Subject: 2013 CX-5 - CHIRP NOISE FROM RIGHT REAR AT 60 MPH OR MORE	Bulletin No: 09-001/13
	Last Issued: 02/15/2013

- This bulletin supersedes the previous bulletin 09-018/12, issued on 04/20/12. The APPLICABLE MODEL(S)/VINS, REPAIR PROCEDURE, PART(S) and WARRANTY INFORMATION have been revised.
- Changes are noted below in Red beside the change bar.

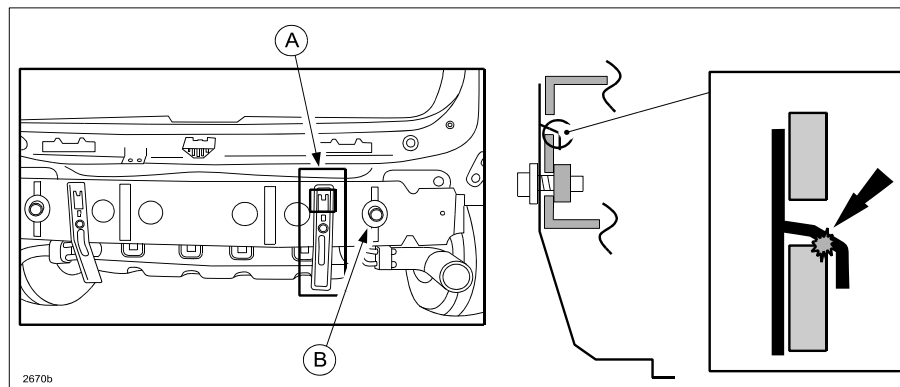
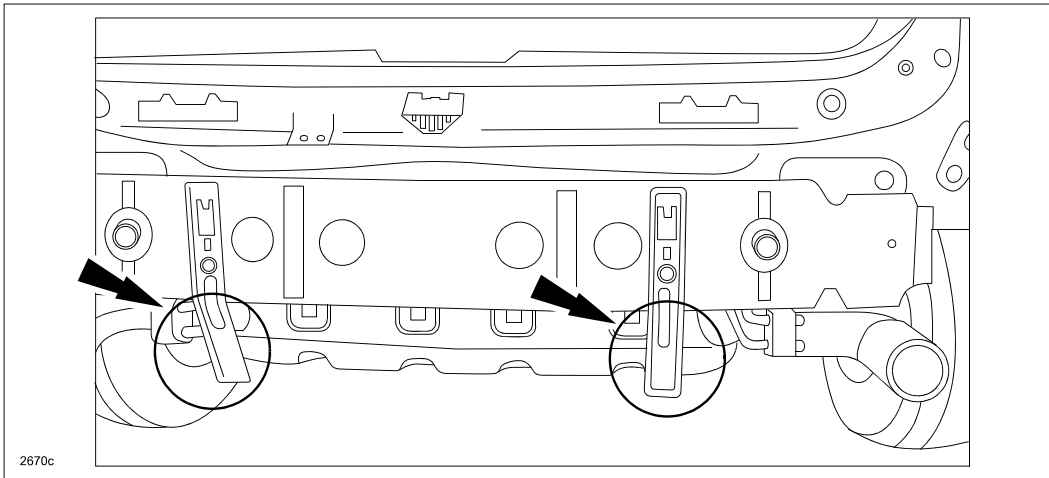
The chirp noise may be caused by the right side rear bumper stay hook (A) contacting the bumper reinforcement (B) at high speed. The shape of the reinforcement hole has been changed on both sides to eliminate the noise.

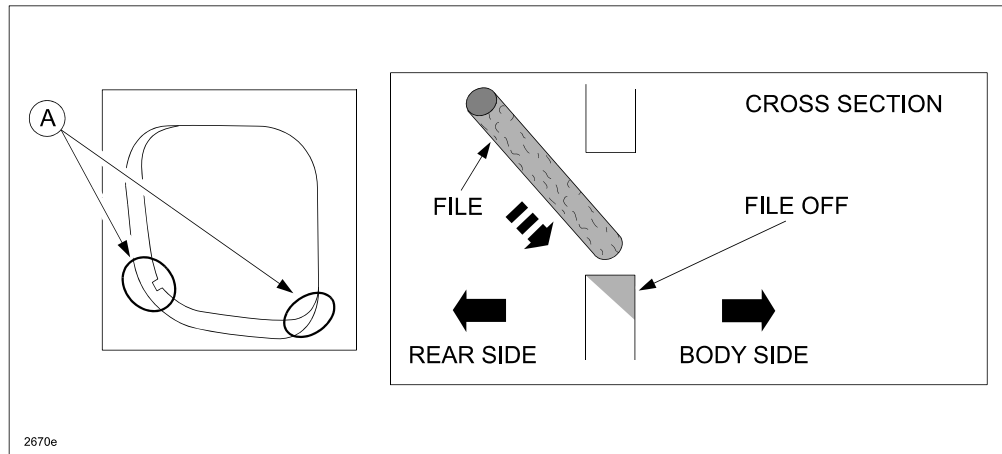
6. File off the inside of both lower hole corners (A) as shown below.

- File off the shaded area until there is no contact between the bumper stay hook and bumper reinforcement.
- Clean the area with an air hose.

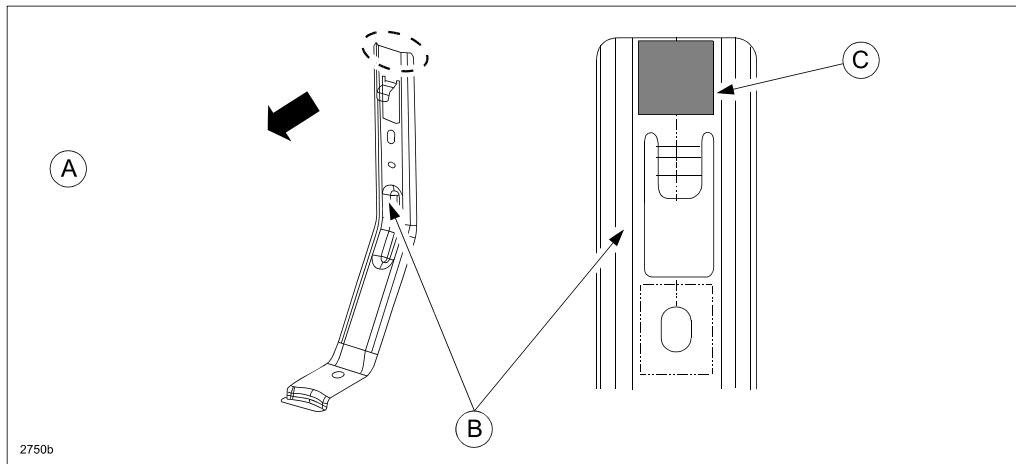
9. Apply (1) one 20 x 20mm pad (B) along the upper edge of the bumper reinforcement, above the hole for hook (A). Repeat Step 9 on the opposite side of vehicle.

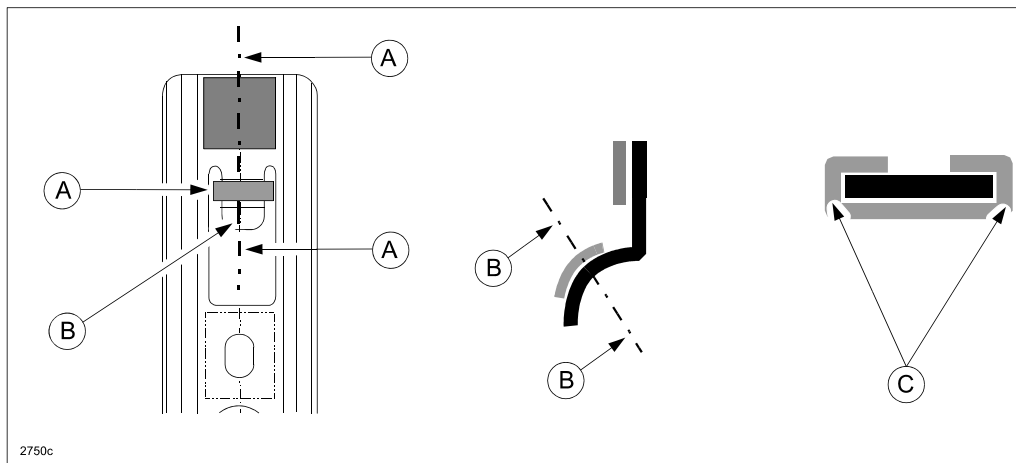
10. (a) Apply (2) two 20 x 20mm pads (C) on the front side of each bumper reinforcement (A), at the upper part of the bumper stay (B).

- (b) Apply (2) two 20 x 10mm pads (A) on the hook (B) of bumper stay. Wrap the pad (C) around both edges of the hook.
